Status: Y ☒ N ☐ U ☐**Seismic Walkdown Checklist (SWC)**Equipment ID No. 1R43-C001A Equip. Class<sup>1</sup> 12Equipment Description DG 1A AIR COMPRESSOR 1A1Location: Bldg. DIESEL Floor El. 130 Room, Area DIESEL GENERATOR ROOM 1A

Status: Y ☒ N ☐ U ☐**Seismic Walkdown Checklist (SWC)**Equipment ID No. 1R43-C001A Equip. Class<sup>1</sup> 12Equipment Description DG 1A AIR COMPRESSOR 1A1**Interaction Effects**

Figure 3 – Surface Oxidation on Anchor Bolt (1R42-S002B)

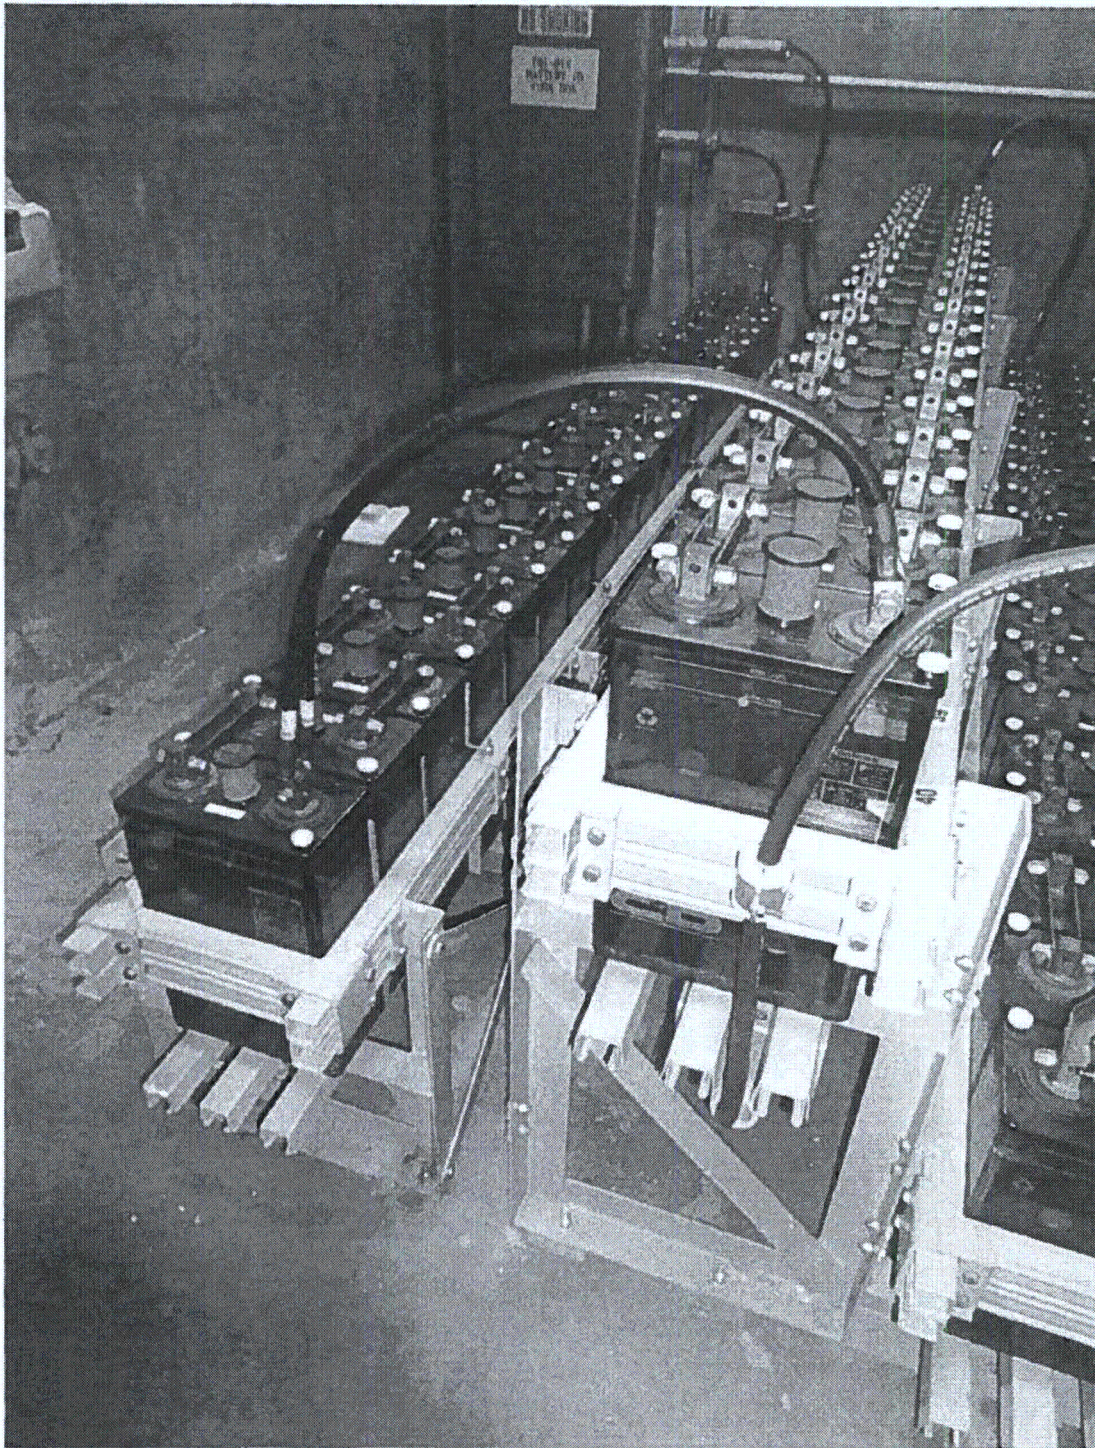
3. Is the anchorage free of corrosion that is more than mild surface oxidation? Y ☒ N ☐ U ☐ N/A ☐  
*There is mild surface oxidation on one of the anchor bolts. Since oxidation is only on the surface, the bolts are not degraded. Therefore, judged not to be a concern.*
